JOINT REGIONAL PLANNING PANEL (Sydney East Region)

JRPP NUMBER:	2015 SYE 026
DA NUMBER:	LDA2015/0032
LOCAL GOVERNMENT AREA:	City of Ryde
PROPOSED DEVELOPMENT:	Construction of two (2) residential flat buildings comprising 311 apartments (134 x 1 bed, 148 x 2 bed, 29 x 3 bed) and basement car parking area. The application includes street upgrades to public roads and upgrade to stormwater and drainage systems and demolition of a local heritage item at 37 Nancarrow Avenue.
STREET ADDRESS:	37-53 Nancarrow Avenue, Ryde.
APPLICANT:	Rothsay Avenue Developments Pty Ltd
NUMBER OF SUBMISSIONS:	11 objections
REGIONAL DEVELOPMENT CRITERIA (SCHEDULE 4A OF THE ACT):	General Development over \$20 Million
LIST OF ALL RELEVANT S79C(1)(a) MATTERS:	Environmental Planning and Assessment Act, 1979 State Environmental Planning Policy (State and Regional Development) 2011 State Environmental Planning Policy No 55 – Remediation of Land (SEPP 55) State Environmental Planning Policy No 65 – Design Quality of Residential Flat Buildings (SEPP 65) State Environmental Planning Policy (Building Sustainability Index: BASIX) 2004 (BASIX) State Environmental Planning Policy Plan (Sydney Harbour Catchment) 2005 (Dee

Figure 10. Sketch plan showing revised configuration of ground floor entries.

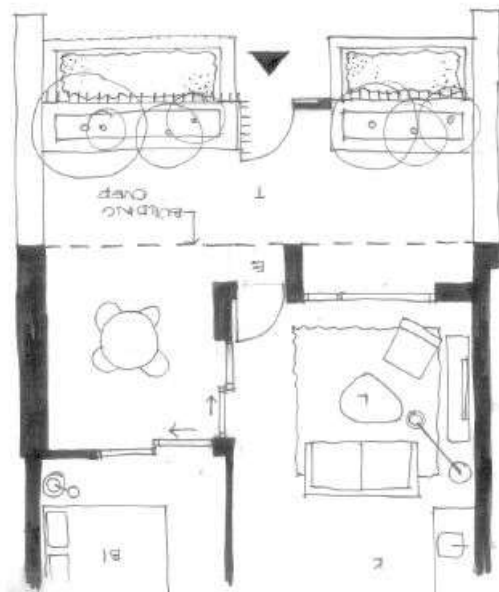
The proposal provides adequate residential address to both Constitution Road and Nancarrow Avenue. Residential lobbies are clearly accessed from public space and are generally offered a sense of space and volume. Ground floor apartments are also configured to address streets and public site links. The Panel encourages these individual ground floor addresses to be configured as formal dwelling entries (rather than as a secondary, purely private address).

External access to ground floor entries of apartments in Stage 6 and 7 have been modified by formalising secondary entries with the repositioning of hard landscaping and a centrally

located gateway (See sketch plan in Figure 10). It is considered that the proposed amended will provide greater distinction to the door entry and are acceptable and formal revised plans will be required by condition. (See condition number 2).
